PROPOSED S4.55/S68 MODIFICATION TO APPROVED DA #10.2021.361.1:
ALTERATION AND ADDITION TO EXISTING COTTAGE, SECONDARY DWELLING
FOR: 3 SHORT STREET, BRUNSWICK HEADS NSW, 2483

DA ADDENDUM:

PROPOSED MODIFICATIONS AND PHASING

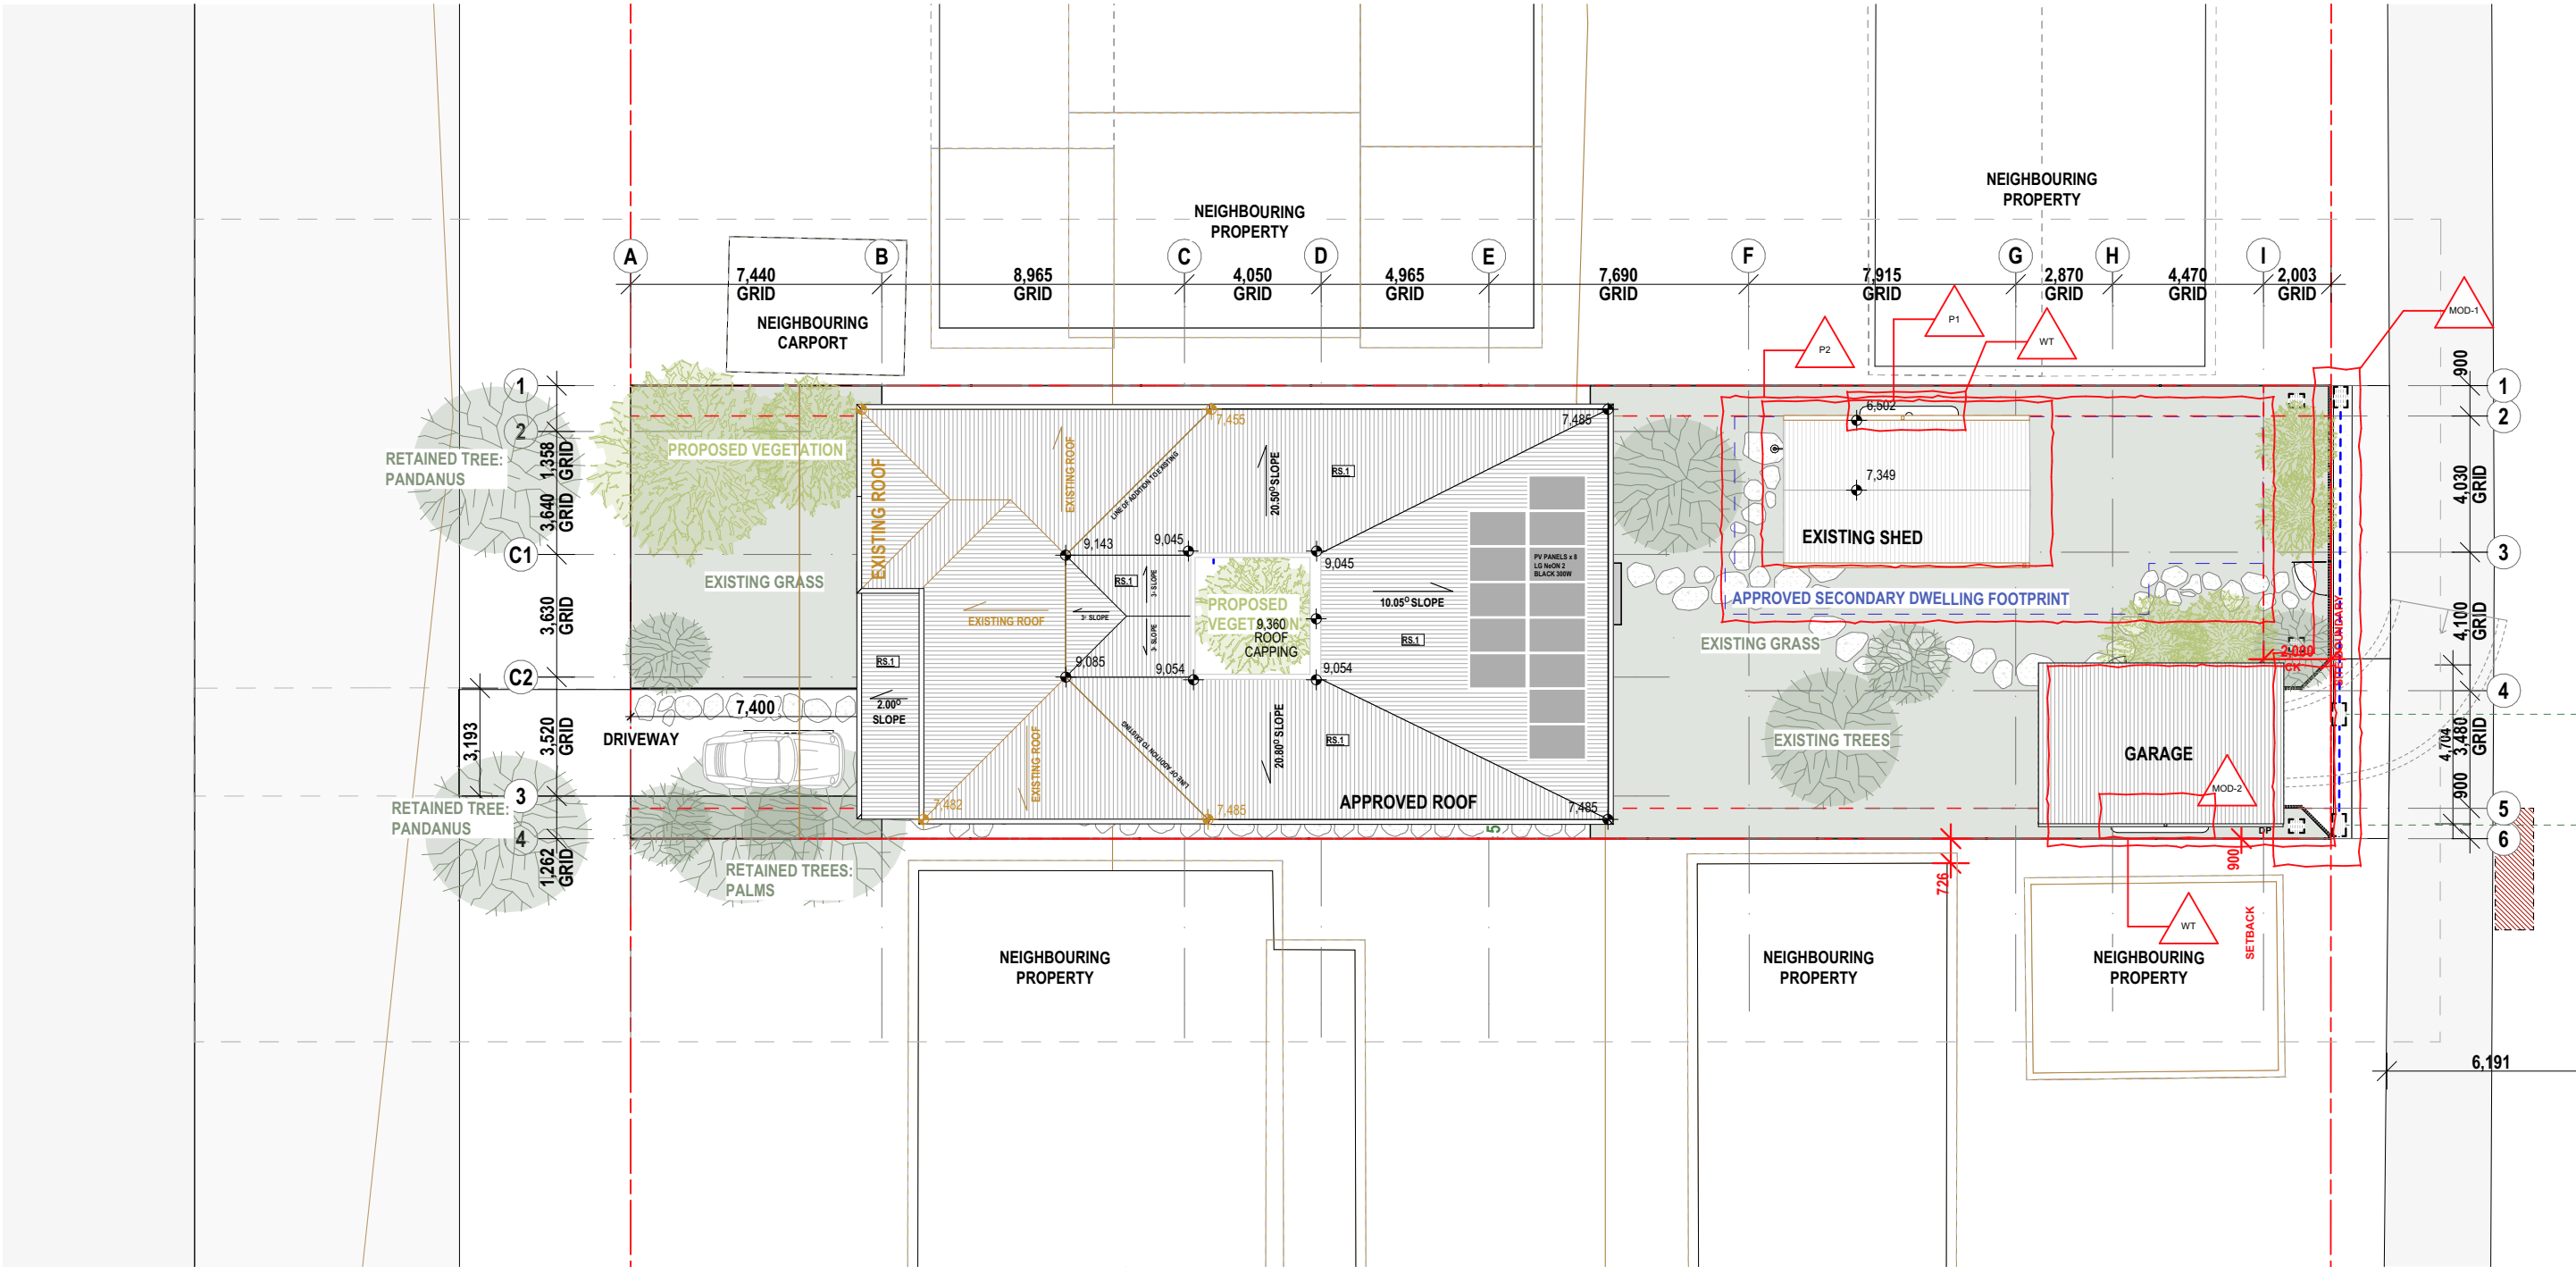
NOTE: THE ABOVE PLAN IS AN IDENTICAL COPY OF THE APPROVED DA, WITH THE MODIFICATION (S4.55) EXTENTS HIGHLIGHTED.
THE FOLLOWING DOCUMENTATION CLARIFIES - AS AN ADDENDUM TO THE APPROVED DA - THE WORKS WITHIN THIS PROPOSED AREA.

NOTE: P1 INDICATES "PHASE 1".
REFER TO COVER PAGE FOR DETAILS ON PHASING.
THE SECONDARY DWELLING IS STILL ANTICIPATED TO BE CONSTRUCTED "IN PHASE 2" AS PER THE APPROVED DA#10.2021.361.1

NOTE TO BSC REGARDING FENCE HEIGHT NGL'S:

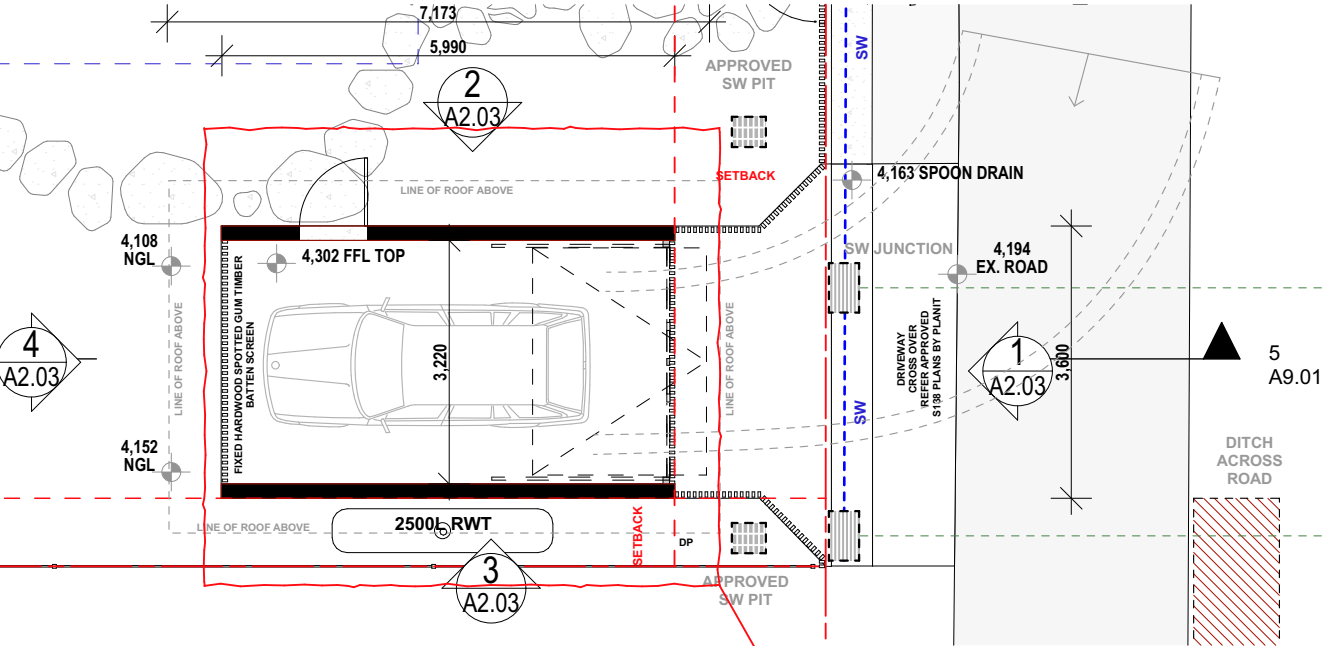
The council's previous position was that the existing stormwater ditch on Ring Lane constitutes the NGL from which the fence height limits were set - resulting in a refusal of the previously proposed fence.

The currently proposed fence is less substantial in height but also articulates back from the stormwater ditch to allow for improved sight triangles from the property. This also mitigates the NGL of the existing stormwater dipping where the fence is constructed, resulting in a compliant outcome.

FP GARAGE FLOOR PLAN
Scale 1:100

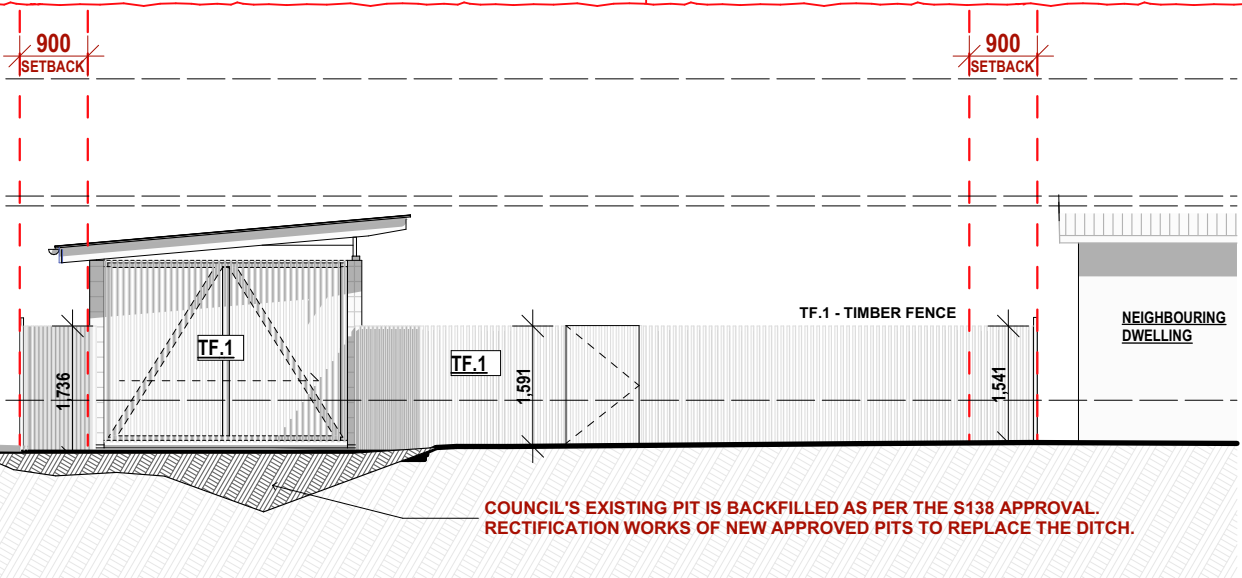
The previously proposed garage was difficult to turn into,
small adjustments have been made to ensure sufficient room
for the B85 vehicle.

The previously proposed gate was part of the fence itself,
but has now been split to become a tilt-door which also
required the deepening of the garage itself to function
cleanly.
